NLS2007012
April 17, 2007

Subject: Response to Request for Additional Information Regarding License Amendment Request for Onsite Spent Fuel Storage Expansion
Cooper Nuclear Station, Docket No. 50-298, DPR-46

**Response to Health Physics Branch Request for Additional Information Regarding
License Amendment Request for Spent Fuel Pool Storage Expansion**

Response to Engineering Mechanics Branch Request for Additional Information Regarding License Amendment Request for Spent Fuel Pool Storage Expansion

Figure 1

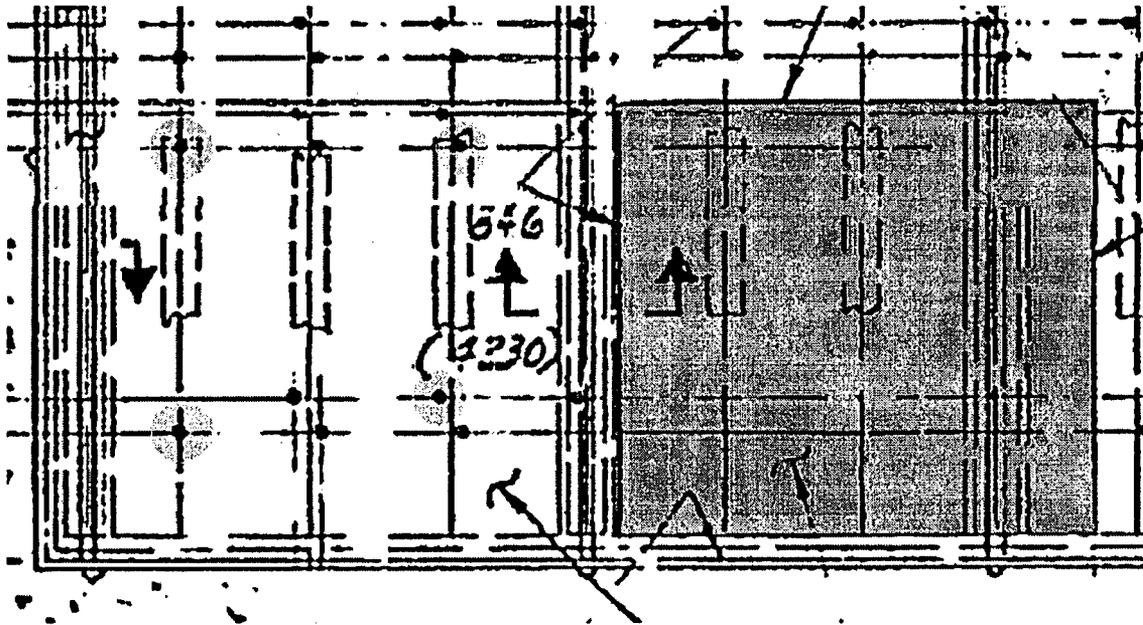
As noted in Section 1.3 of the Holtec report, "The existing swing bolts are used to fasten the platform to the pool floor rendering them into a fixed appurtenance to the pool slab".

Please provide a summary of the stress analysis of the swing bolts and swing bolt anchorages to the pool slab for the loads transmitted by the Rack A fuel rack and platform. Please provide a drawing showing the anchorage pattern.

The swing bolts and swing bolt anchorages have been analyzed for the loads transmitted by the Rack A fuel rack and platform to demonstrate that the stress levels meet the applicable ASME Section III, Subsection NF limits. The stress levels have been determined based on strength of materials formula. The following table summarizes the results for the swing bolts and swing bolt anchorages.

Burns and Roe drawings Number 4228, Rev. 11, and Number 4230, Rev. 14, are provided as part of this response. The locations of the hold-down bolts are shown on Drawing No. 4228, in the section labeled Plan – Fuel Storage Pool @ El. 962'3". The dashed lines running East-to-West (North is shown on the drawing) show the location of the embedded "W" sections to which the ¼-inch stainless steel (SS) liner plate pieces were welded. The small dots on these lines depict the location of the hold-down bolts ("swing-bolts") which were welded directly to the same embedded "W" sections, and to the ¼-inch SS liner plates. The anchorage pattern is shown in Figure 1.

Drawing No. 4230, Sections 859-859 and 860-860, shows the details of the welded connection between the swing-bolt clevis and the embedded "W" section/liner plate. The connection of the "W" sections to the cast-in-place anchors is shown in Section 846-846.

This figure is an excerpt from the structural detail information (section labeled *Plan - Fuel Storage Pool @ EL. 962'-3"*) provided on Burns and Roe Drawing 4228. The anchorage pattern of the four (4) "swing-bolts" utilized to secure the platform for new Rack A is shown by the light grey shading. For reference purposes, the shaded area is the existing pool-floor cask bearing pad (1-inch plate).

Figure 2
Rack A Platform Finite Element Model

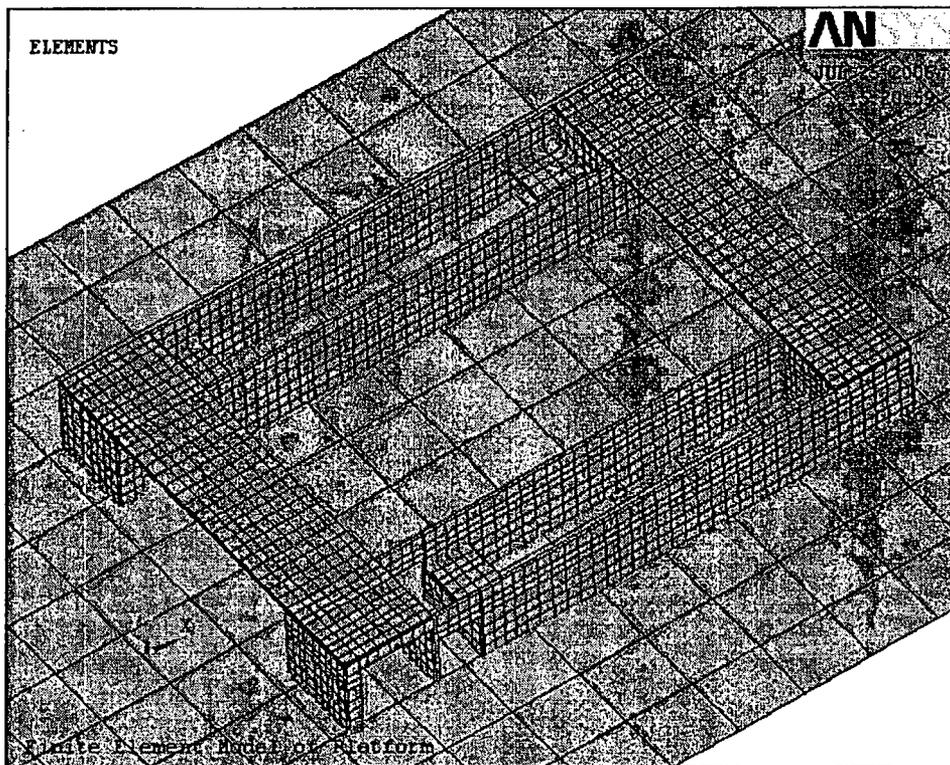
Section 2.2 of the Holtec report notes that: “Because the platforms are not an integral part of the rack, their stress analysis and structural qualification are not addressed in this licensing report”.

Please provide a summary of the stress analyses for the Rack A and B platforms. Please provide the drawings for the platforms.

A stress analysis of the Rack A platform has been performed using the finite element code ANSYS. The model, which is comprised of 4-noded shell elements, is shown in Figure 2. The finite element model is fixed at the base since the Rack A platform is restrained against lateral motion through its connection to four existing swing bolts on the SFP floor. Each of the swing bolts is preloaded to 10,000 lbs when the platform is installed to increase the frictional resistance at the SFP liner/platform interface. The maximum pedestal loads (in the horizontal and vertical directions) from the rack dynamic analysis are applied to the top surface of the Rack A platform model as nodal forces. Stresses in the platform components and welds are shown to meet ASME, Section III, Subsection NF and Appendix F for Level A and Level D service loadings, respectively. The minimum safety factors for the Rack A platform are summarized in the following table.

Platform and Components		Safety Factor	
		Level A (OBE)	Level D (SSE)
Platform	Membrane	1.24	1.07
	Membrane plus Bending	1.84	1.18
	Bearing	26.0	N/A
Welds	Bracket	10.5	4.05
	Mainframe Panel	2.79	2.75
	Top Pad	1.63	1.74
	Swing Bolt Hold Down Plate	1.64	N/A

Figure 3
SSE Response Spectra for Vertical Ground Motion
(Note: Vertical ground motion is derived by applying a factor of 2/3 to the above spectrum)

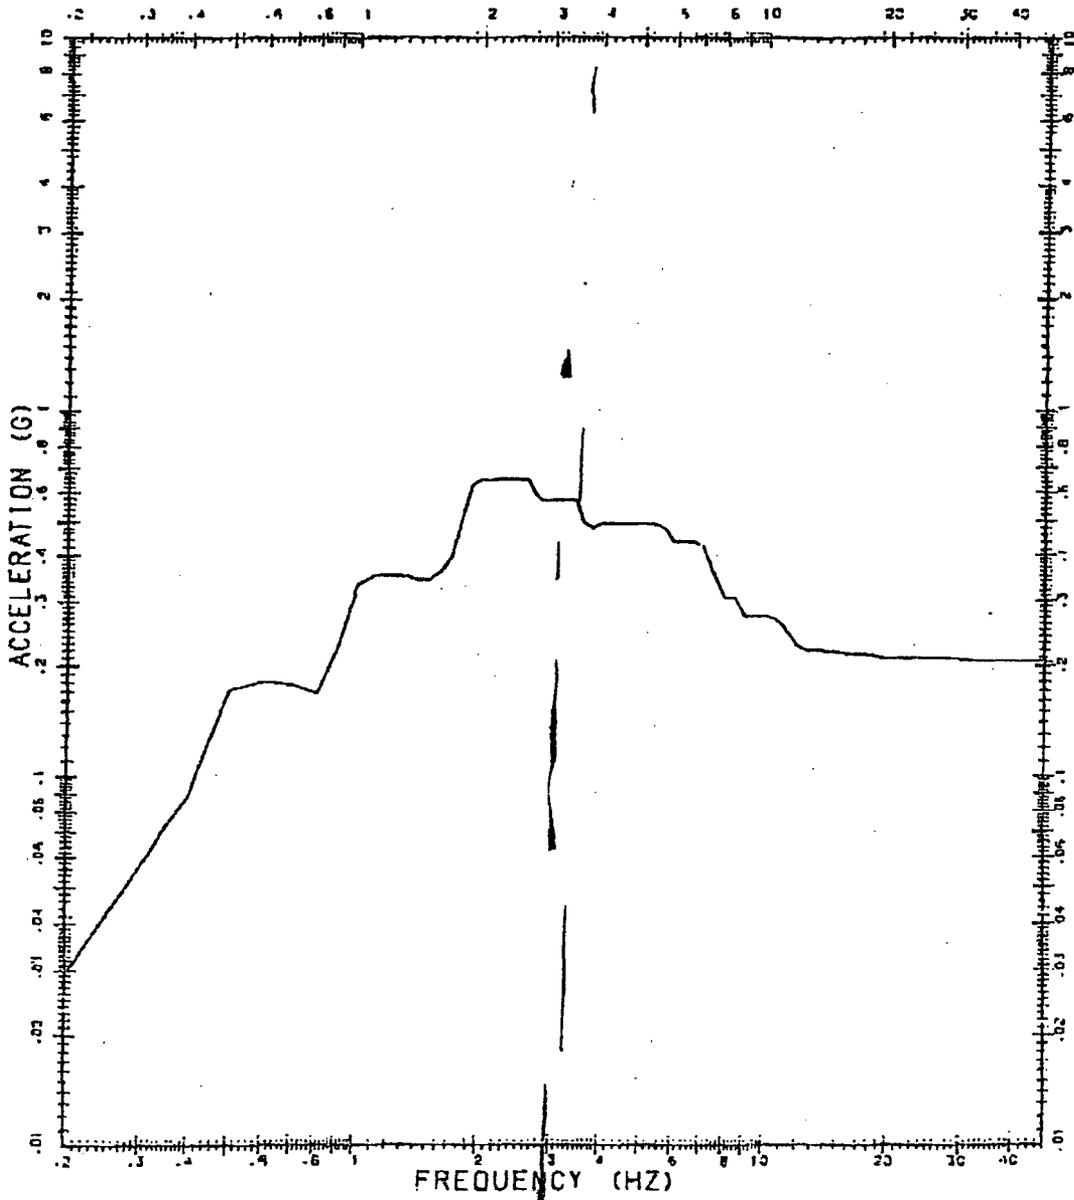
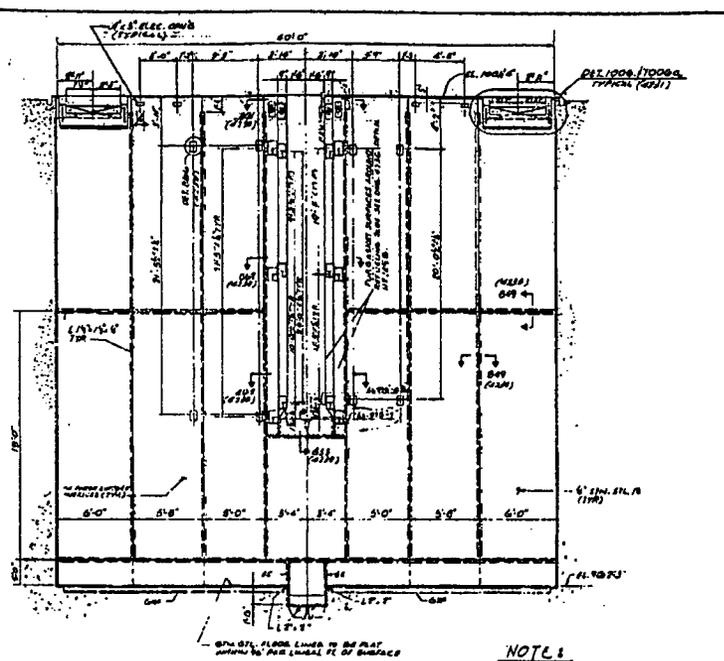
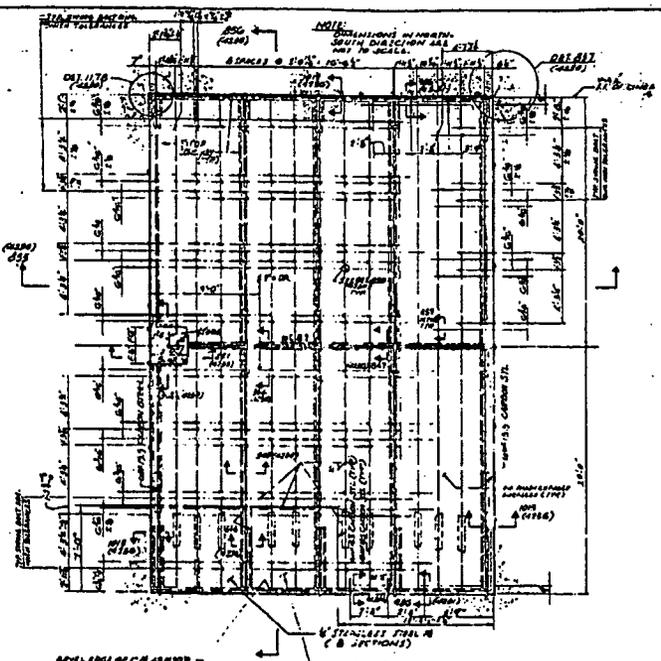
Table 6.7.1 of the Holtec report specifies 4 percent damping for Operating Basis Earthquake (OBE) and 5 percent damping for Safe Shutdown Earthquake (SSE) as input data for the rack seismic analysis. Table 1 of NRC Regulatory Guide 1.61 specifies 2 percent damping for OBE and 4 percent damping for SSE for welded steel structures. Please discuss the appropriateness of the damping values used in the analysis.

The CNS design and licensing basis information found in USAR Section XII-2.3.5.2.5 indicates that “*Steel Frame Structures*” are to be analyzed using a damping value of 2.0 percent and “*Welded Assemblies*” are to be analyzed using a damping value of 1.0 percent when conducting dynamic analyses using seismic response spectra methodology. The selection of the CNS design and licensing basis ground response spectra for the seismic design analyses of safety-related Structures, Systems, and Components (SSCs) was completed prior to the October 1973 issuance of NRC Regulatory Guides 1.60, “*Design Response Spectra for Seismic Design of Nuclear Power Plants,*” and 1.61, “*Damping Values for Seismic Design of Nuclear Power Plants.*” The CNS-specific ground response spectra does not completely envelope the Regulatory Guide 1.60 spectra, which precludes the direct use of the higher (less conservative) damping values permitted by Regulatory Guide 1.61 for the analysis of welded steel structures.

The subject CNS OBE floor response spectra (at 4 percent damping) and SSE floor response spectra (at 5 percent damping), were not directly utilized to conduct dynamic response spectra-type analyses of the proposed new storage racks. The subject floor response spectra for the 976’-0” elevation of the Reactor Building were utilized to create artificial acceleration time histories of the dynamic input motion applicable to the location of the proposed fuel storage racks. The synthetic “conversion” of the subject floor response spectra information to artificial time-history input motion was confirmed to be accurate by ensuring that “output” floor response spectra, created from these artificial time-history input motions, would adequately and appropriately envelope the CNS OBE and SSE floor response spectra originally provided to the analysts. These “verified” artificial time histories were then used as input data to conduct the non-linear dynamic analyses of the new storage racks, which are base-supported on the storage pool floor, elevation 962’-3.”

Time-history dynamic input motion information is not dependent on an assumed damping level in the structure being dynamically loaded, as the “input” information is in the format of acceleration versus time, rather than a format of acceleration versus structural response (frequency or period). As such, the damping level of the “input” floor response spectra would not be critical to the dynamic analyses of the proposed new storage racks.

The numeric values of the structural damping values assumed in the rack structures were confirmed to be as listed in Table 6.7.1 of the Holtec report (4 percent for the OBE dynamic analyses, and 5 percent for the SSE dynamic analyses). These internal damping values are not in accordance with the CNS USAR, nor are they consistent with Regulatory Guide 1.61. The appropriate structural damping value for use in conducting each of the dynamic analyses for CNS is 1 percent. As such, the assumed structural damping values utilized in the rack dynamic analyses are potentially non-conservative.

As the lowest fundamental mode of horizontal structural response in the proposed new storage racks was determined by analysis to be approximately 7 Hz, and because the input dynamic response was applicable to an elevation higher than the pool floor (976’-0” versus 962’-3”), the effect of this non-conservative assumption is not significant.
